DCHC MPO

Draft CTP Comments (as of 02/21/17)

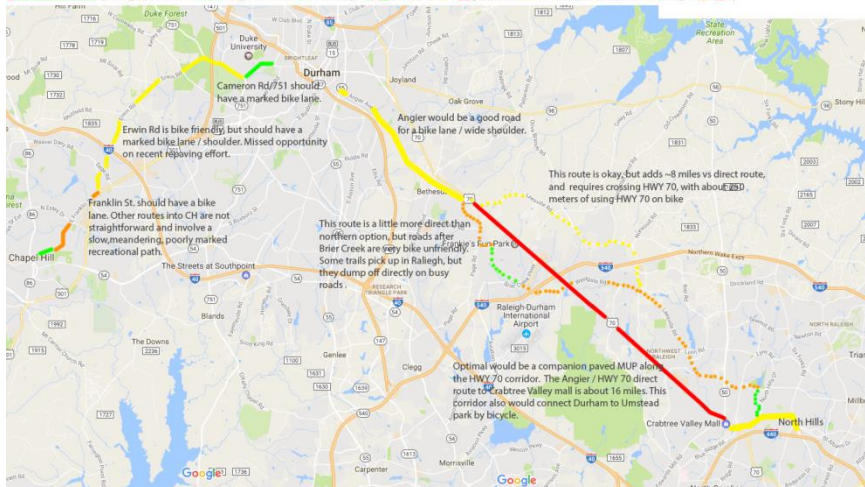
Thanks for taking the time a few weeks ago to host the Durham transit open house at the bus station. I promised to send in some feedback on a few items, but got a bit sidetracked.

I've attached a picture of some items. I've got thoughts all over town, but these are a few bigger ones. I left out some generally know about topics like the mess of the downtown loop, and kept this generally bike focused. The 70 bike route could use bus service between the cities.

Blue = Existing Draft Bike Focus Corridor
Green = Problem areas / need

Green = Current bike lane / trail / neighborhood road for most commuter level cyclists.
Yellow = No real bike accommodations, okay for stronger riders, but not great.
Orange = Particularly troubling route on bike even for strong riders.

Red = Ideal corridor, but not available to bikes

Dotted lines = current options for getting to Raleigh.
